MEETING SUMMARY

Westbound I-70 Mountain Corridor - Concept Development Process Technical Team (TT) Meeting

Wednesday, March 8, 2017

Close Interchange at US 6
Move to East (Top of Floyd Hill)

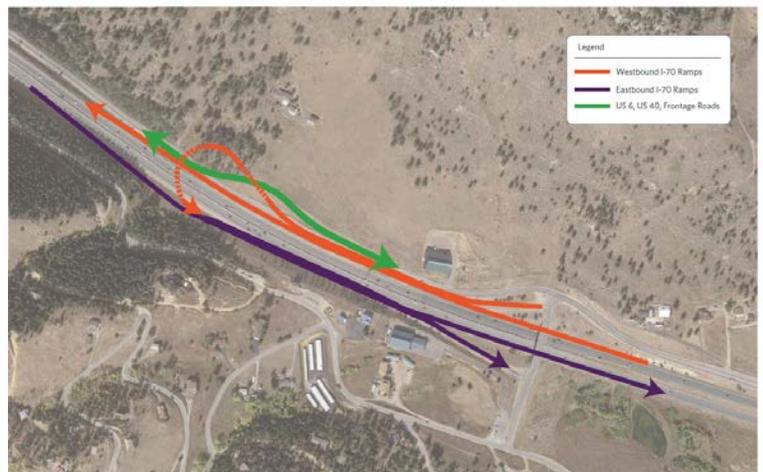
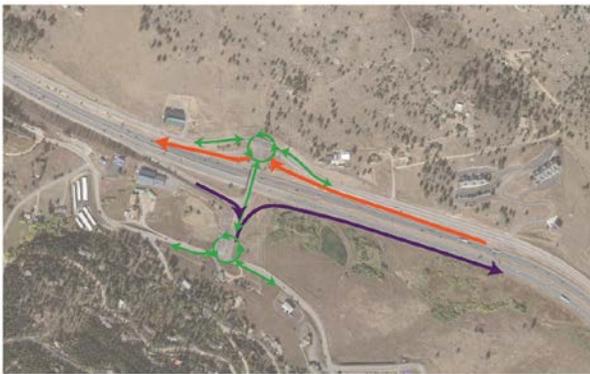
The Close Interchange at US 6 (move to top of Floyd Hill) concept, pictured above, closes the US 6 interchange and moves it to the top of Floyd Hill. Traffic from US 6 will need to go back up the hill. This option does not appear to be optimal for trucks or community. Intersections at both ends will be modified.

Partial/Complete Closure of US 6 Interchange Shift Other Movements to East

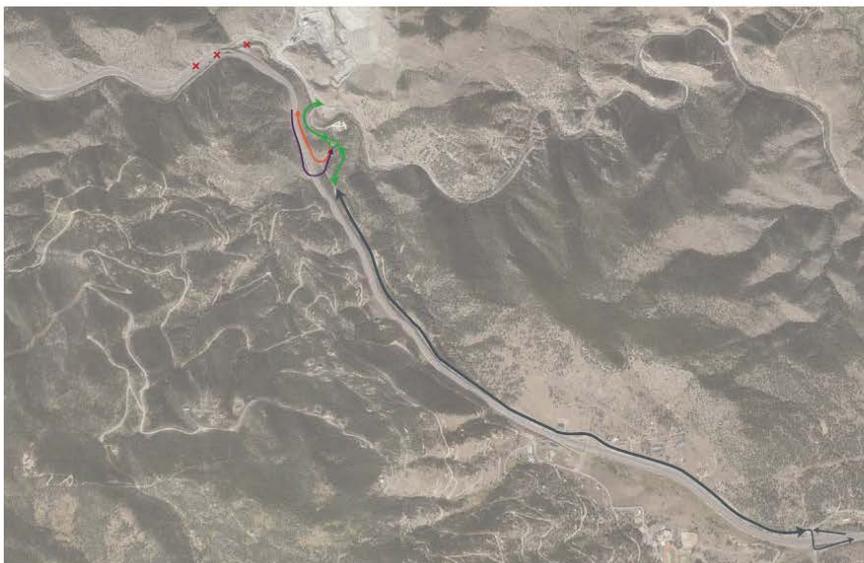
These above maps show an interchange complex that moves some of the US 6 movement approximately 1500 feet up Floyd Hill. The top drawing looks like it handles everything, but the purple arrow is very steep.

Reconfigure US 6 Interchange Full Movements at Current Location

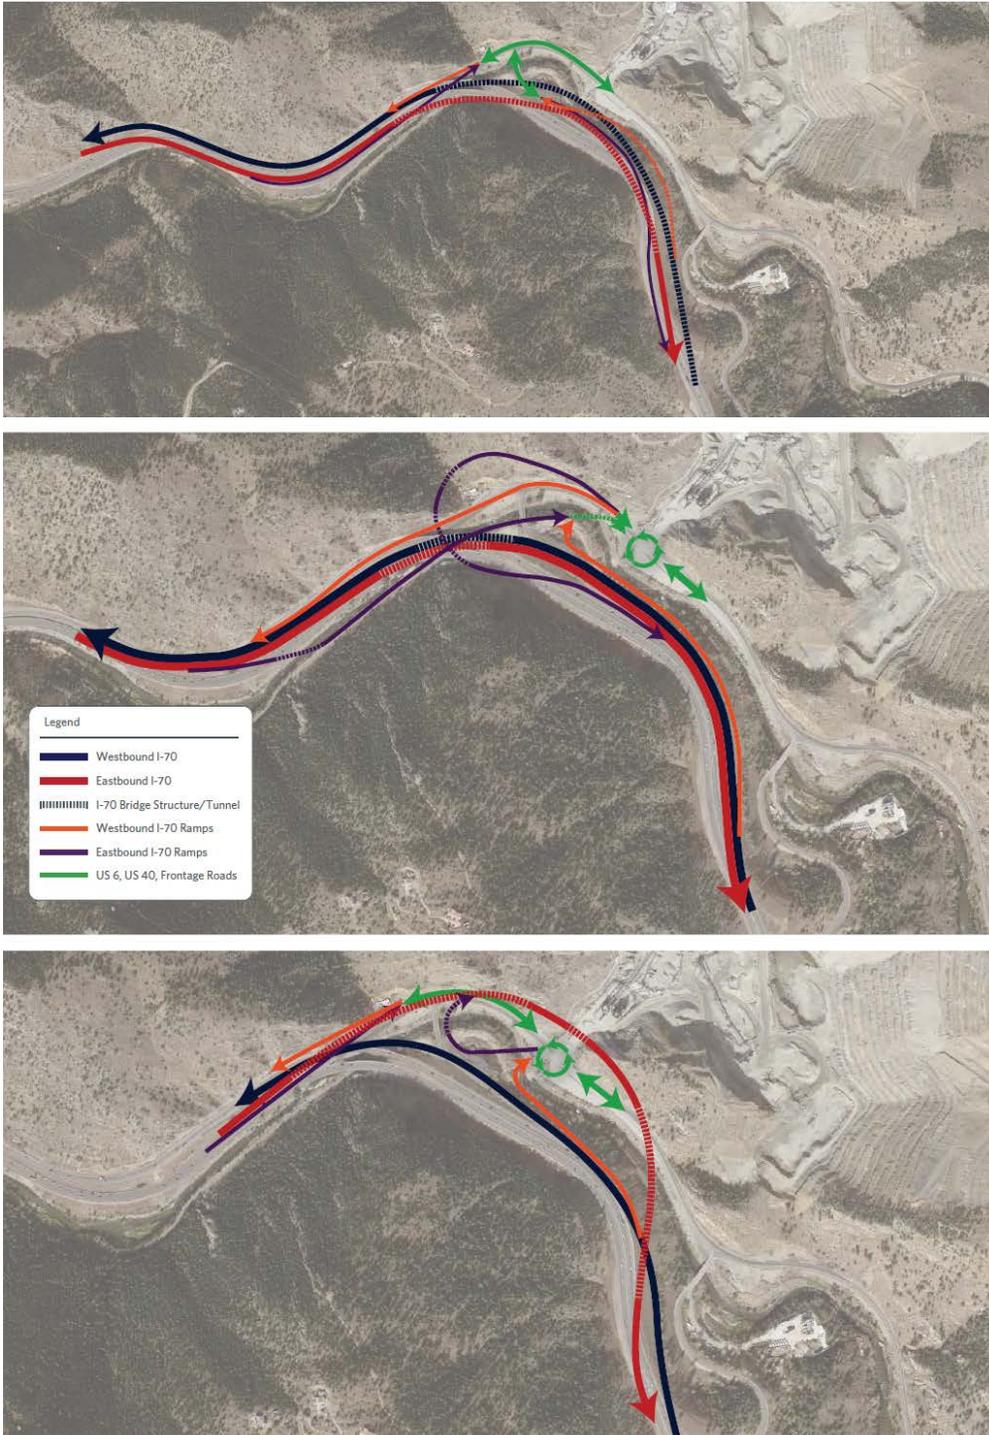
Keeping the interchange where it is will take a considerable amount of land to make these movements geographically appropriate for the context. It is very challenging to fit them all in because of topographic constraints and with Clear Creek.

- Roundabout arrows are going the wrong way! **The maps pictured above have already been fixed to address this issue.**
- Exits and onramps will be moved to the right of the highway at the US 6 interchange to meet driver expectations
- Context is addressed differently in each option.
- There are a lot of different interests to meet for the reconfiguration of the US 6 interchange.
- It is important to think about truck movement, e.g. turning. This will be greatly impacted by how the interchange functions.
- The Greenway is part of the evaluation criteria for all of Segment 1 Concepts. However, some of the concepts prioritize the Greenway, some prioritize community needs, some prioritize safety. All of the concepts involve different tradeoffs.
